Entergy Nuclear Operations, Inc.
Pilgrim Nuclear Power Station
600 Rocky Hill Road
Plymouth, MA 02360

Pilgrim Nuclear Power Station License Renewal Application Annual Update
Supplement (TAC MC9669)

LETTER NUMBER: 2.10.046

**Entergy Response to Additional Information Related to
Pilgrim License Renewal Annual Update Changes**

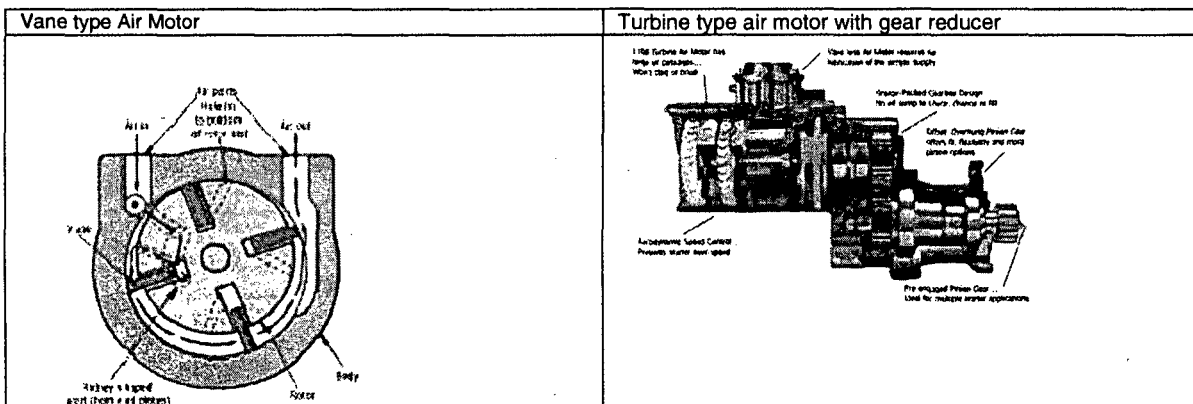
Pilgrim's LRA Drawing M219 showed a component identified as a "Motor Oil Fogger" in the piping from the Emergency Diesel Generator (EDG) air receiver tanks to one of the two sets of air start motors on the "A" EDG. The drawing showed "Motor Oil Foggers" in the piping on both sets of the air start motors for "B" EDG. The "Fogger Housing" described a unique component type whose integrity would be necessary to assure accomplishment of EDG intended function. PNPS License Renewal Annual Update Letter # 2.09.074 discussed the deletion of the "Fogger Housing" resulting in the following questions.

- How "Fogger Housing" is no longer required to support EDG intended function?
- How the pressure boundary function is being achieved?

- The new EDG air start motors do not require lubricated air, so the motor oil foggers with their “Fogger Housings” are no longer required.
- When the foggers were removed they were replaced with air piping components maintaining the pressure boundary.

The Motor Oil Fogger and its housing are no longer needed to support the EDG intended function because the recently installed turbine type air motor does not require lubricated air. The original vane type motors utilize sliding vanes that rub against the motor housing walls and because of this internal friction vane type motors require oil foggers to provide constantly lubricated air.

The turbine type air motor uses blades to convert pneumatic power to mechanical power; the internal parts do not rub against the walls. The turbine type motor has permanently lubricated bearings and does not require an oil fogger as part of its air supply system.
